Model: General RTB	Date: 4-Feb-03	No.: RGene013b
--------------------	----------------	----------------

Subject: Service remarks at installation		Prepared by: T. Itoh	
From: Technical Service Sec. Service Planning Dept.			
Classification:	<input type="checkbox"/> Troubleshooting <input type="checkbox"/> Part information <input type="checkbox"/> Action required		
	<input type="checkbox"/> Mechanical <input type="checkbox"/> Electrical <input type="checkbox"/> Service manual revision		
	<input type="checkbox"/> Paper path <input type="checkbox"/> Transmit/receive <input type="checkbox"/> Retrofit information		
	<input checked="" type="checkbox"/> Other (Specification change)

Model: Model J-P2CF		Date: 30-Apr-03	No.: RG367001
Subject: Firmware Modification		Prepared by: H. Someya	
From: 1st Tech. Support Sec. Service Support Dept.			
Classification:	<input type="checkbox"/> Troubleshooting <input type="checkbox"/> Mechanical <input type="checkbox"/> Paper path <input type="checkbox"/> Other ()	<input checked="" type="checkbox"/> Part information <input type="checkbox"/> Electrical <input type="checkbox"/> Transmit/receive	<input type="checkbox"/> Action required <input type="checkbo

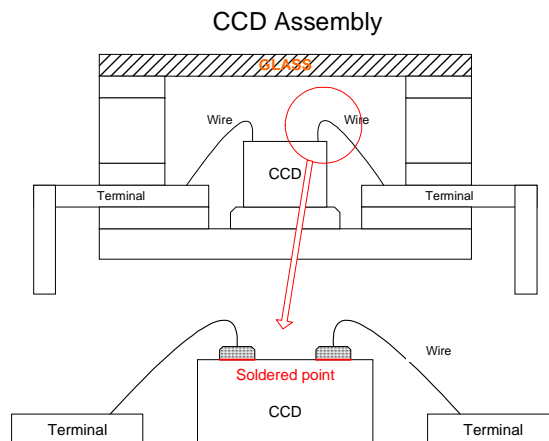
- SC142 (White Level Detection Error)
- SC101 (Exposure Lamp Error)
- Colored vertical lines/bands/background (see photo).

The adhesive used to attach the glass to the CCD assembly was changed, but it generated a gas when exposed to the heat from the PCB during machine operation. The gas caused the soldered points of wires on the CCD to oxidize and deteriorate, resulting in poor contact.

The adhesive has been changed back to the original type.

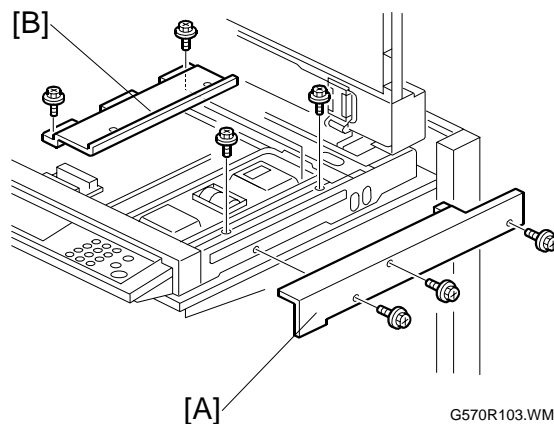
Retrofit parts (lens block assemblies) will be provided to the field FOC for all affected units. Therefore, at the next service visit or when the issue is reported, please replace with P/N B1169455.

6. Lens block assembly (Sensor board unit) [C] (⌘ x 4, ⌘ x 4)

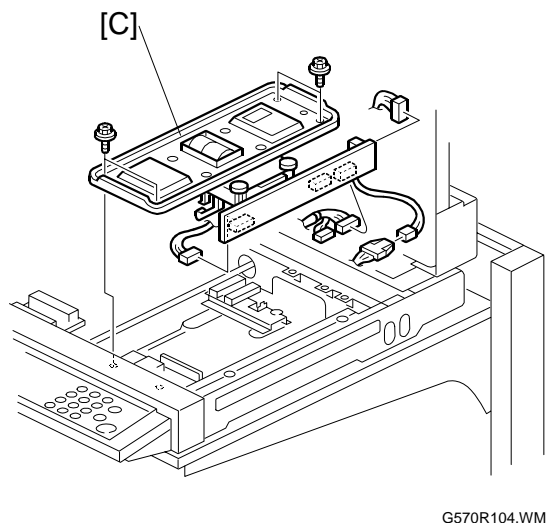
1. Open the ARDF/platen cover
2. Exposure glass
3. Rear cover
4. Right cover [A] (⌘ x 3)
5. Inner cover [B] (⌘ x 4)

Note: Do not remove the paint-locked screws.

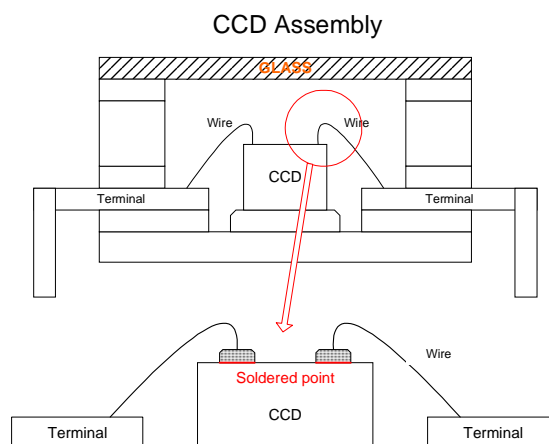
- SC142 (White Level Detection Error)
- SC101 (Exposure Lamp Error)
- Colored vertical lines/bands/background (see the photo).

The adhesive used to attach the glass to the CCD assembly was changed, but it generated a gas when exposed to the heat from the PCB during machine operation. The gas caused the soldered points of wires on the CCD to oxidize and deteriorate, resulting in poor contact.

The adhesive has been changed back to the original type.

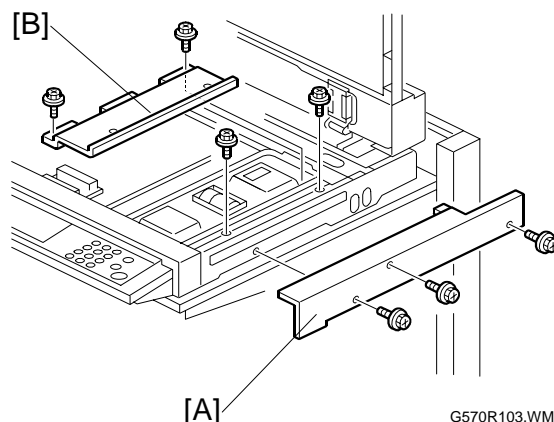
Retrofit parts (lens block assemblies) will be provided to the field FOC for all affected units. Therefore, at the next service visit or when the issue is reported, please replace with P/N B1169455.

6. Lens block assembly (Sensor board unit) [C] (⌀ x 4, ⌀ x 4)

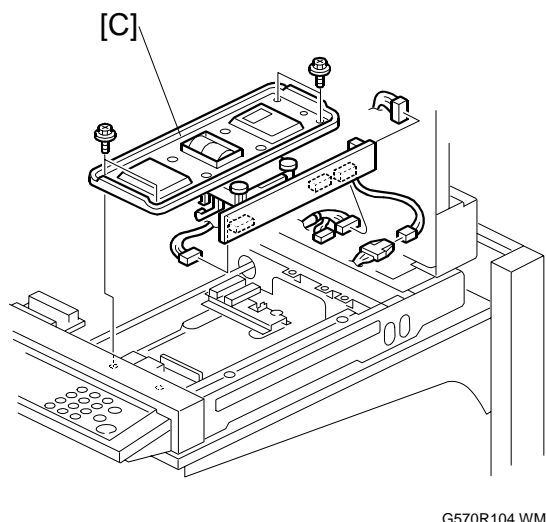
1. Open the ARDF/platen cover
2. Exposure glass
3. Rear cover
4. Right cover [A] (⌀ x 3)
5. Inner cover [B] (⌀ x 4)

Note: Do not remove the paint-locked screws.

7. After replacing the lens block assembly (Sensor board unit), **check that the current setting of SP4-205 (Black ADS Level) is at its default of 70.**
 - ***If this SP is at a value of 8, this can cause incorrect background detection in ADS mode and lead to dirty background.***
8. Adjust the following SP modes according to the following scanner adjustment procedure.
 - SP4-008 (Scanner leading edge magnification)
 - SP4-010 (Scanner leading edge registration)
 - SP4-011 (Scanner side-to-side registration)
